Village of Grantsburg

Village Board Meeting Agenda Monday, February 9, 2026 at 4:00 p.m. Village Board Room, 316 S. Brad Street

RE: Change Order 01
Village of Grantsburg
Grantsburg WWTP Improvements
SEH No. 184139 71.50

Change Order No. 1 to the Grantsburg WWTP Improvements project is enclosed. This Change Order includes six (6) items previously approved as individual line items by the Village Board and two (2) items that have not been approved. SEH recommends approval of Change Order No. 1 to incorporate the following changes into the Contract with Market & Johnson, Inc. (Contractor):

REVISION SCHEDULE		
REV. #	DESCRIPTION	DATE
1	WCD-01	9/08/2025

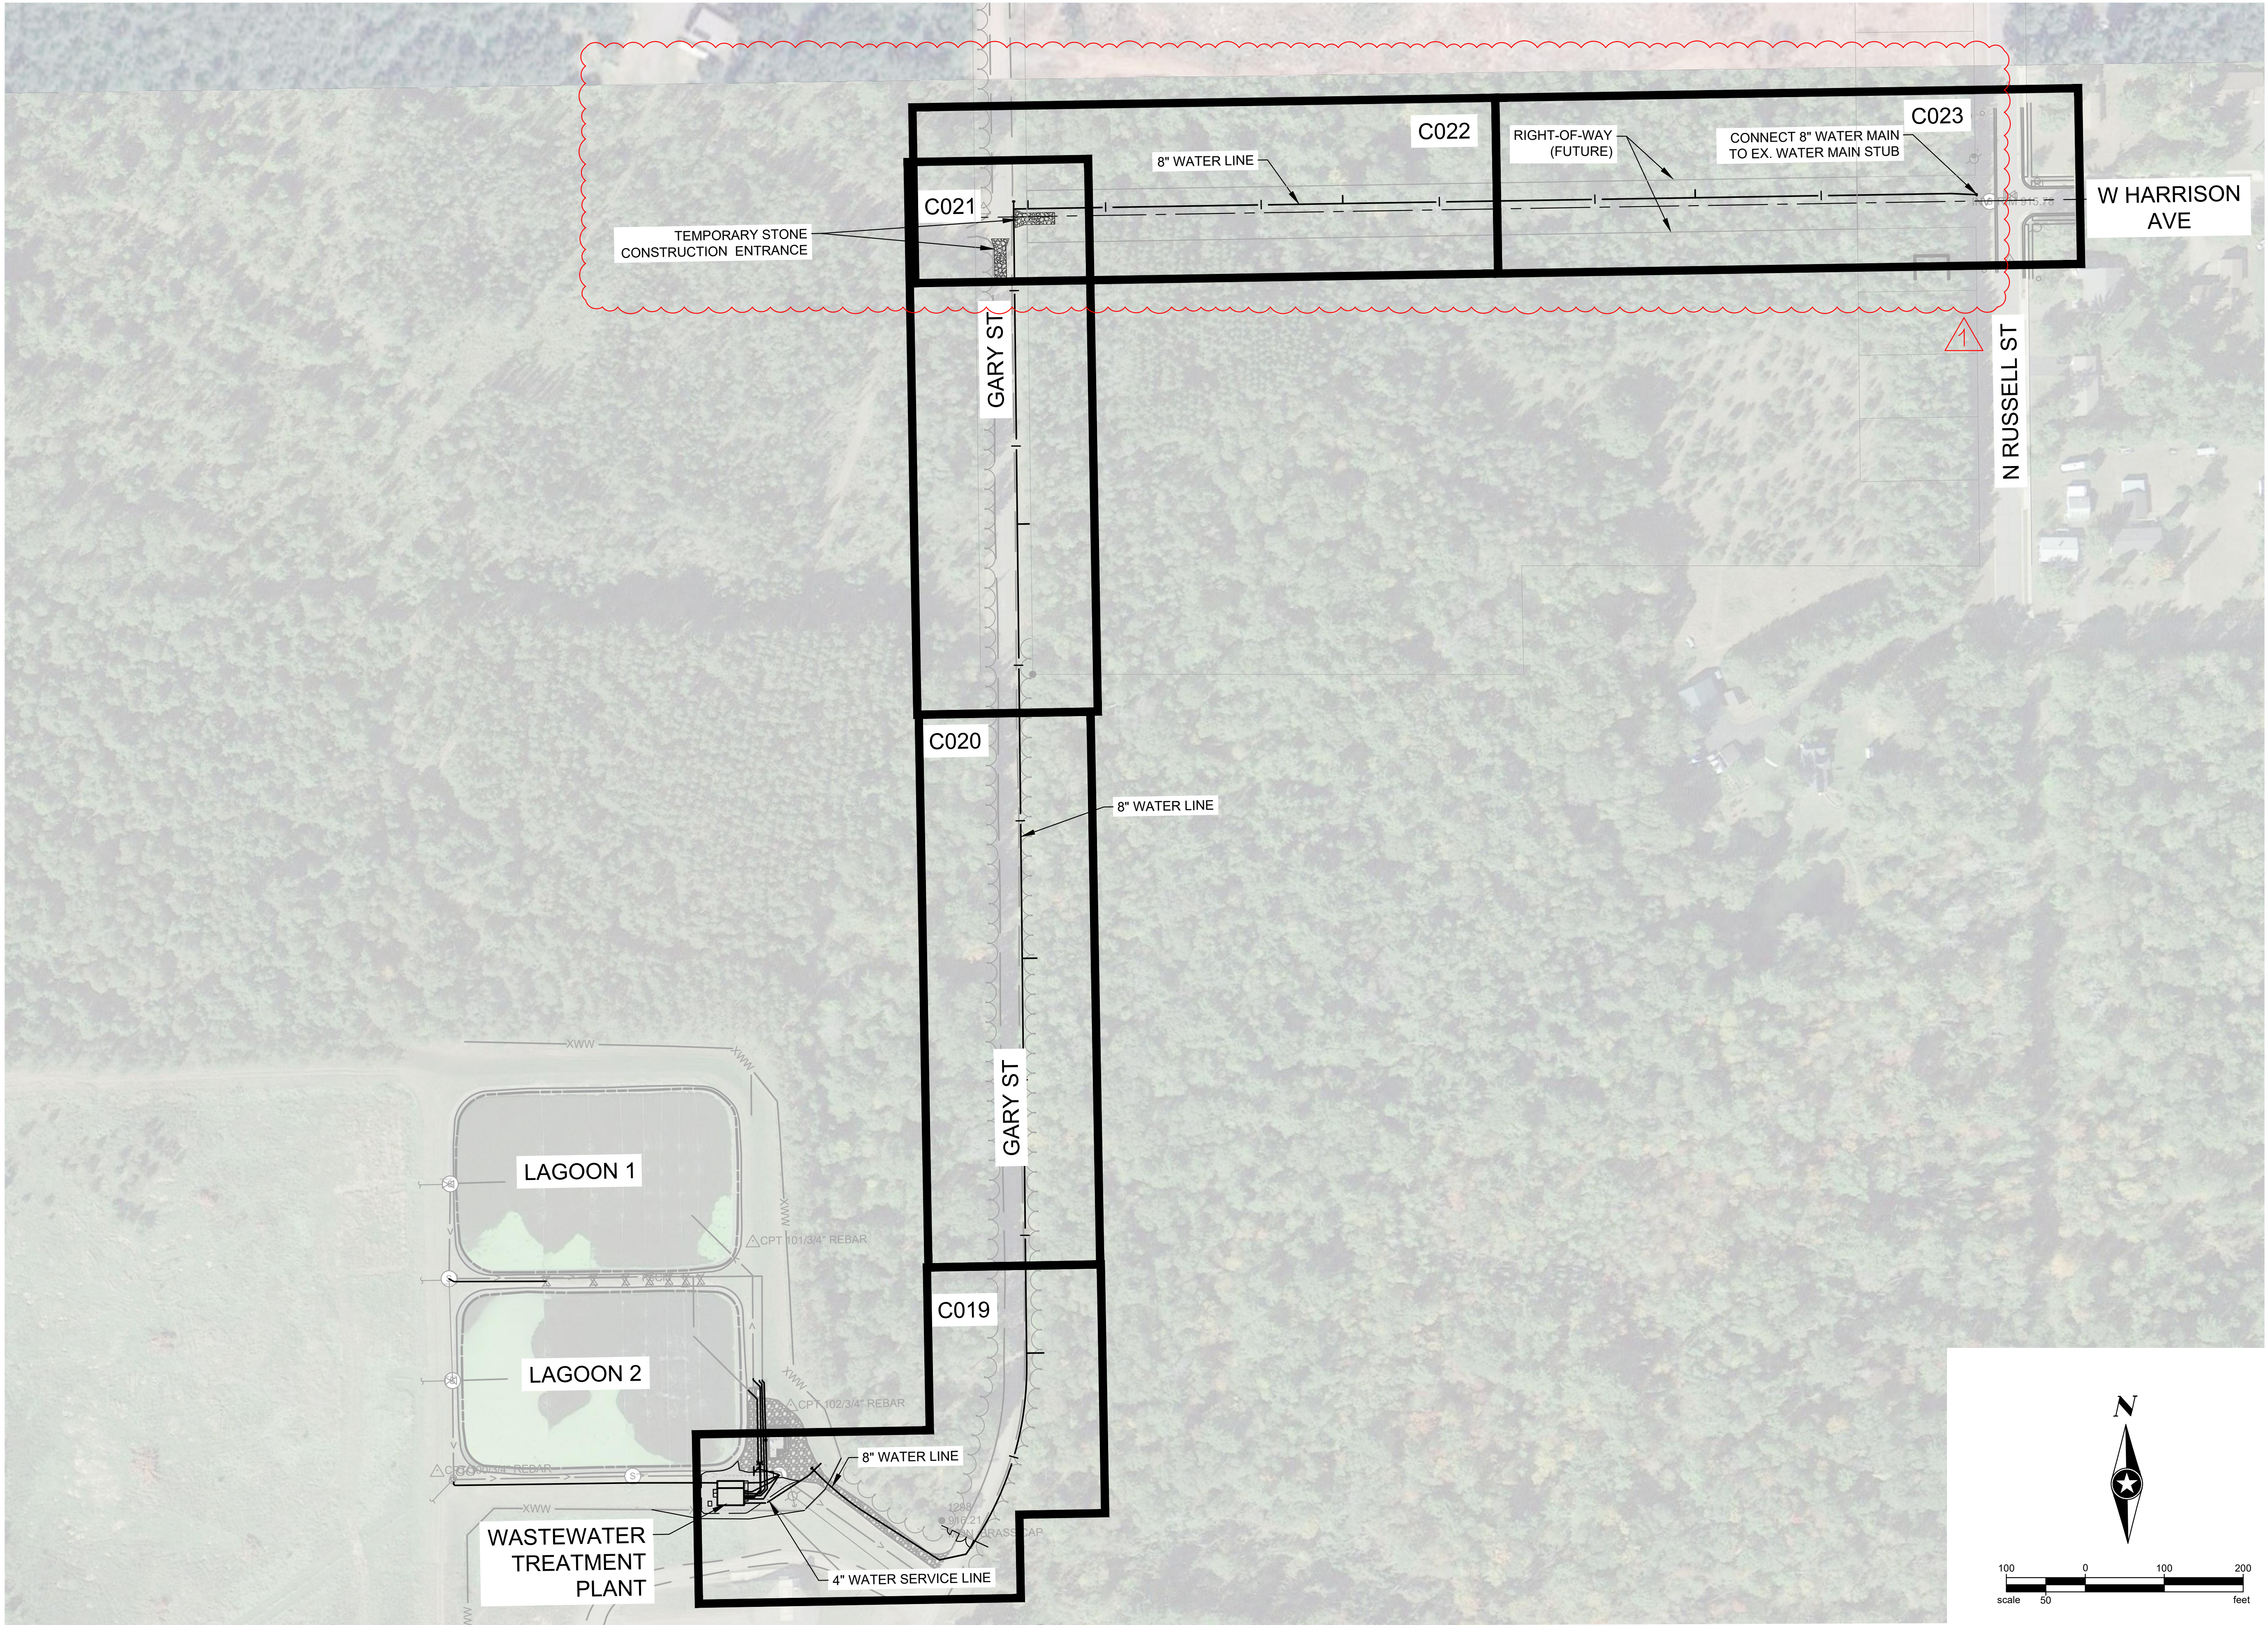
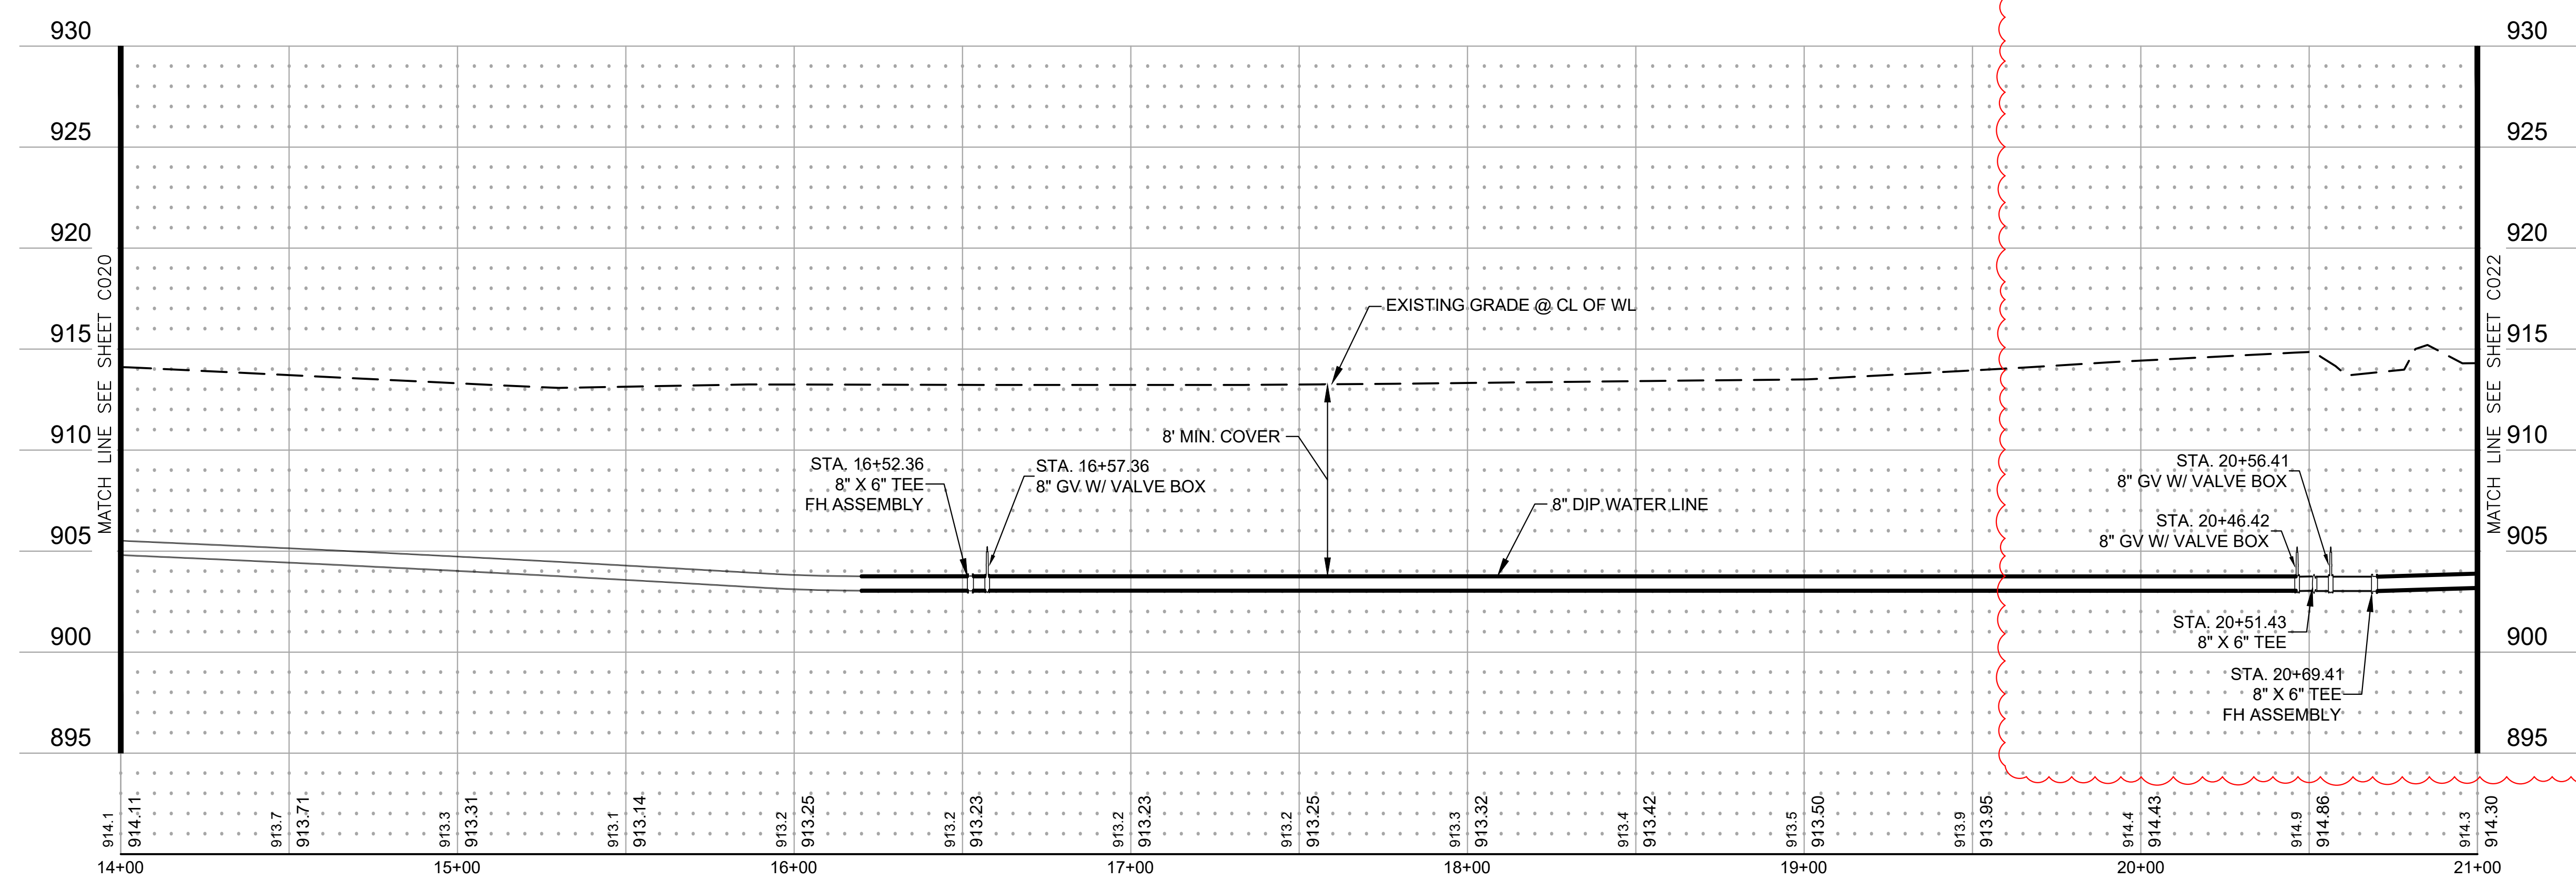
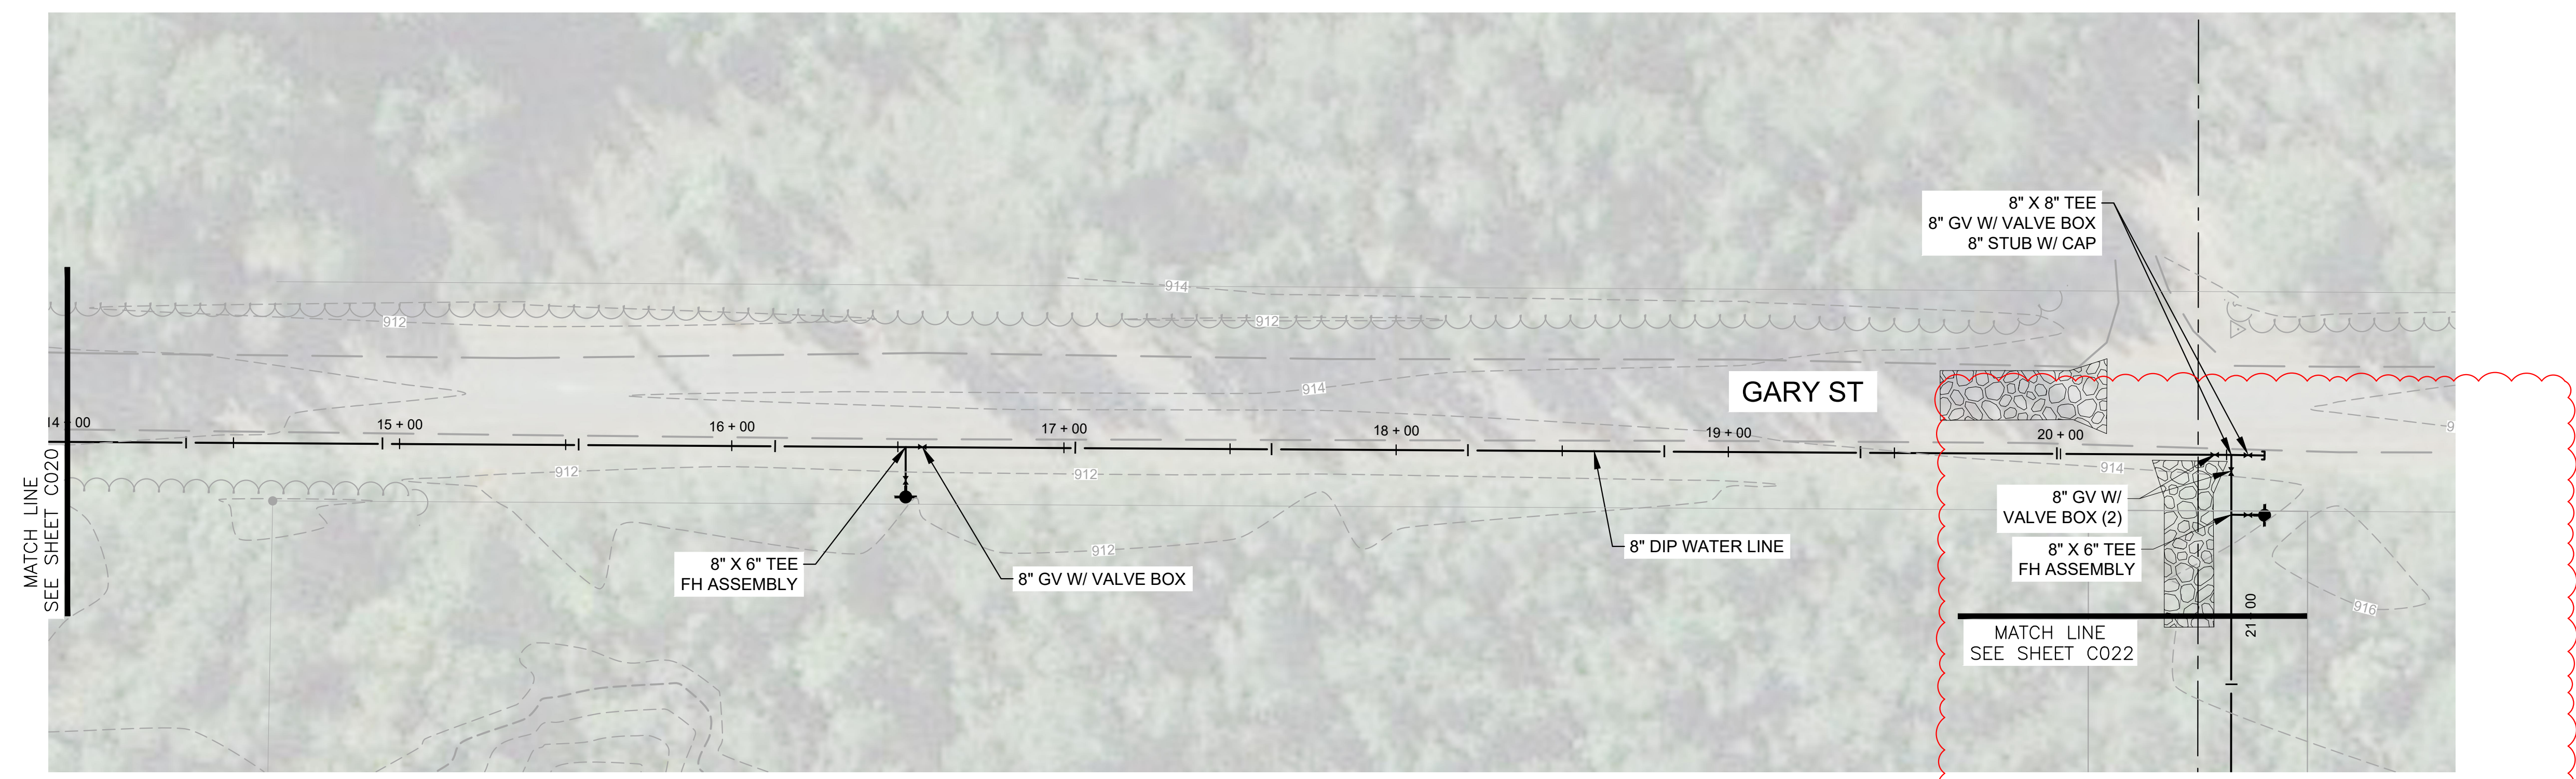
- **Change Order Request #02 – Watermain Alignment Revision (WCD #1)**
The alignment adjustment results in no cost impact and no change to Contract Time; COR #02 is recommended for approval. This change was approved by the Grantsburg Village Board on December 8, 2025.
